U.S. DEPARTMENT OF TRANSPORTATION
FEDERAL HIGHWAY ADMINISTRATION
and
VIRGINIA DEPARTMENT OF TRANSPORTATION

ENVIRONMENTAL STUDIES DOCUMENT

Route 7 Corridor Improvements
Fairfax County, Virginia
State Project: 0007-029-128, B610 ,C501, P102, R202; UPC: 52328
Federal Project: DEMO-5A01(432)
EA-FONSI Date: November 15, 2017
From: Reston Avenue
To: Jarrett Valley Drive

Figure 2: Revised Conceptual of the At-grade Intersection of Route 7 at Baron Cameron Ave / Springvale Road

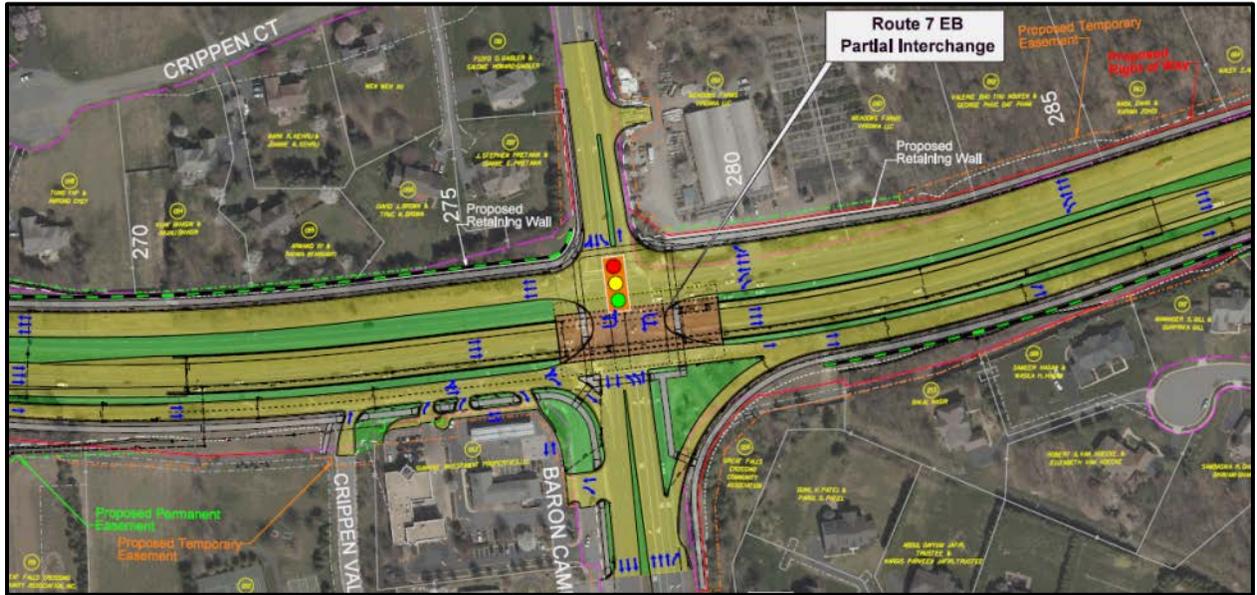
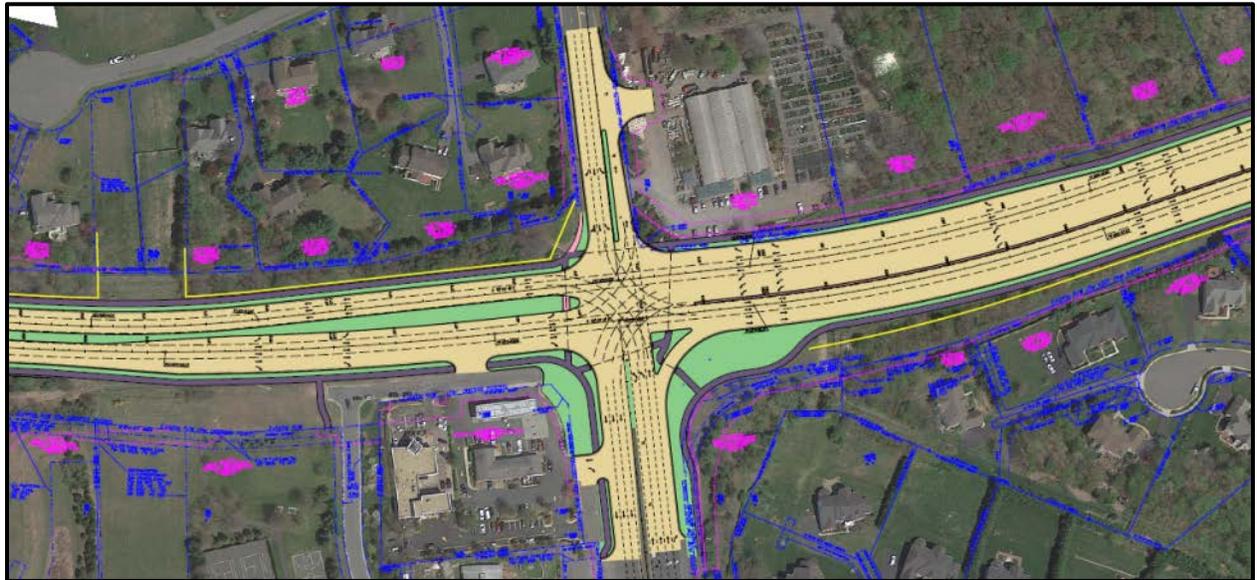
A design change to the Build Alternative was made to replace the proposed partial interchange of Route 7 at Baron Cameron Avenue/Springvale Road (Figure 1) with an at-grade intersection (Figure 2) upon which is the basis of this supplemental evaluation. VDOT has conducted additional traffic analyses to determine how the proposed changes would affect the anticipated operations of the proposed improvement. The at-grade intersection constitutes a diminishment from the 2040 operational performance (LOS and the safety performance) of the 2040 partial interchange. However, the at-grade intersection still provides a better operational performance over the 2040 No-Build alternative. **Table 2** compares the Existing (2011), Future (2040) No-Build, Future (2040) Build (Partial Interchange) and Future (2040) Build (At-grade Intersection) AM and PM Delay and LOS for the signalized intersection at Route 7 and Baron Cameron Avenue.

Figure 3: Revised Typical Section of the At-grade Intersection of Route 7 at Baron Cameron Ave / Springvale Road

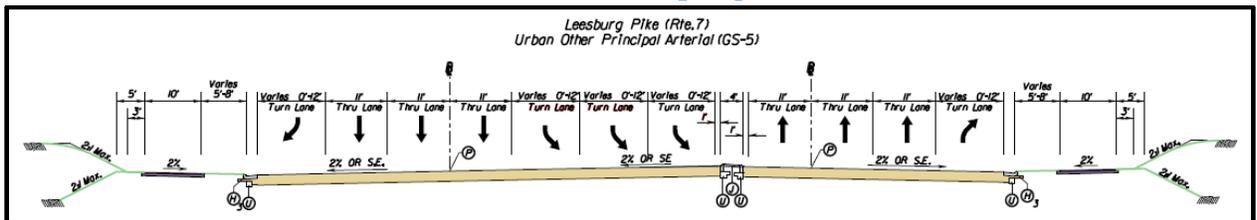
The extent of this design revision is approximately from the Riva Ridge Drive intersection to approximately 680 feet west of the Delta Glen Court intersection. Figure 3 represents the revised typical section for the proposed at-grade intersection of Route 7 with a new triple left turn movement from Route 7 westbound to Baron Cameron Avenue southbound.

Figure 4: Reduction in Right of Way as Result of the Revised Build Alternative at the intersection of Route 7 and Baron Cameron Avenue / Springvale Road

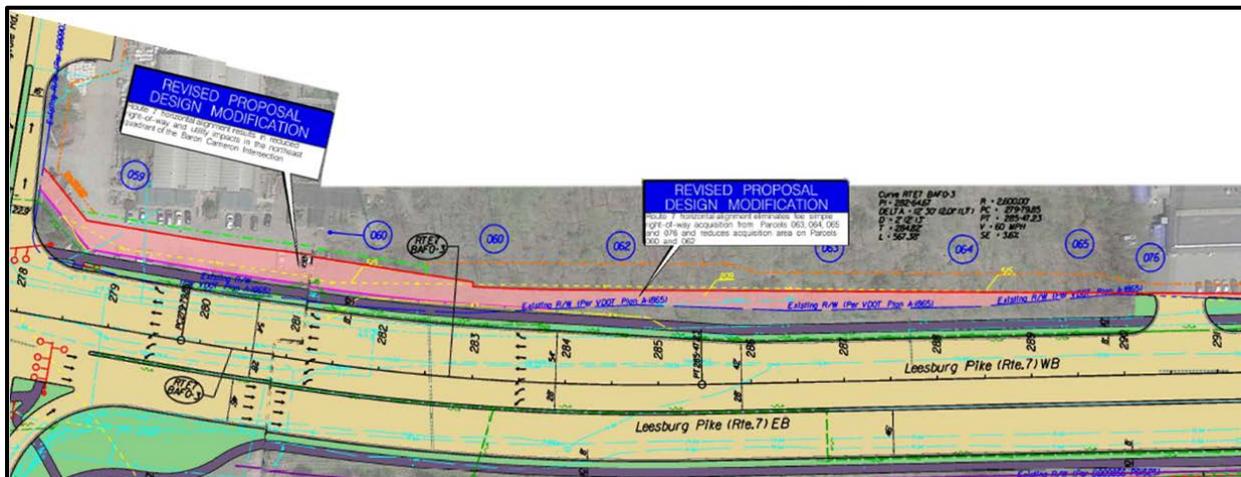
The revised Build Alternative design concept reduces fee-simple right-of-way acquisition on Parcel 059 and 060 by 0.23 acres and 0.12 acres respectively, and by 0.09 acres on Parcel 062. It also eliminates fee-simple right-of-way acquisition from Parcels 063, 064, 065, and 076. No additional relocations are required as result of the revised design.
